Access Compliance Report

Public Rights-of-Way

Intersection ID: 32288	Main Street: OLD_ARDREY_KELL_RD	Cross Street: ALLYSON_PARK_DR	Location: NE
ADA ID: F3014E4B2B4B	Ramp Type: BlendTrans1	Initial Pass/Fail: Fail	Overall Compliance: No
Severity Score: 21.25			
Codes/Mitigation Info/Possible Solution		Field Measurements/Component Compliance

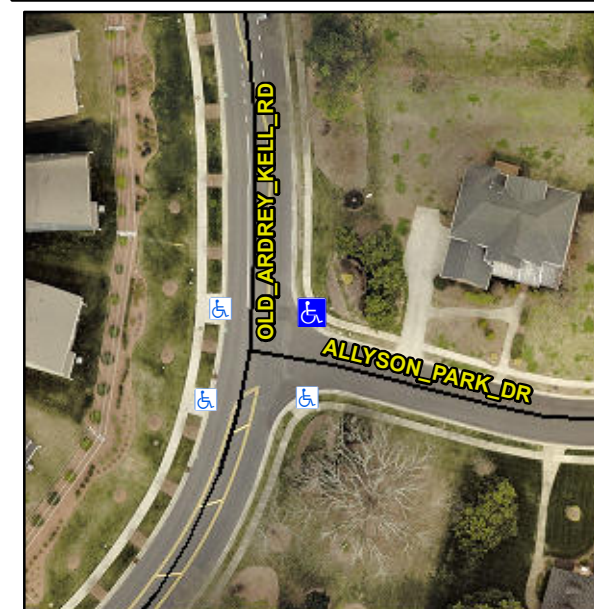
CURB LIP 0.5

Not Found, R304.5.1, R304.5.3

Compliance	Description	Data	Compliance	Description	Data
N/A	Ramp Length (in)	45.5	Yes	BlendTrans Slope (%)	4.7
No	Ramp Width (in)	47.5	No	BlendTrans XSlope (%)	5.5
N/A	Flare Type LT	N/A	N/A	Flare Type RT	N/A
N/A	Flare Slope LT (%)	N/A	N/A	Flare Slope RT (%)	N/A
N/A	Flare Traversable LT?	N/A	N/A	Flare Traversable RT?	N/A
N/A	Landing Length (in)	N/A	N/A	DWS Provided?	N/A
N/A	Landing Width (in)	N/A	N/A	DWS Contrast?	N/A
N/A	Landing Slope (%)	N/A	N/A	DWS Length (in)	N/A
N/A	Landing X Slope (%)	N/A	N/A	DWS Full Width?	N/A
N/A	Landing Curb? (Y/N)	N/A	N/A	DWS Offset (in)	N/A
N/A	Shared Landing?	N/A			
N/A	Gutter Ponding?	N/A	N/A	Gutter Slope (%)	N/A
N/A	Gutter Lip Ht (in)	N/A	N/A	Gutter X Slope (%)	N/A
N/A	Painted X Walk1?	No	N/A	Painted X Walk2?	No
	X Walk 1 Direction	To W		X Walk 2 Direction	To S
	X Walk 1 Width (in)	N/A		X Walk 2 Width (in)	N/A
	X Walk 1 Slope (%)	3.0		X Walk 2 Slope (%)	0.7
	X Walk 1 X Slope (%)	2.8		X Walk 2 X Slope (%)	4.4

N/A	Ramp inside XWalk1?	N/A	N/A	Ramp inside XWalk2?	N/A
	Road Slope (%)	4.1		Clear Space?	N/A
	Road X Slope (%)	1.1	N/A	Clear Space to XWalk (in)	N/A
N/A	Any Obstructions?	N/A	N/A	Storm Grate/Utility Hazard?	N/A
	Obstruction Type			Storm Grate/Utility Type	
		N/A			N/A
			Yes	Surface Condition? (G/P)	Good
			No	Curb Slope (%)	5.4

Remove & Replace Curb Ramp With Two New Directional Ramps or Equivalent.
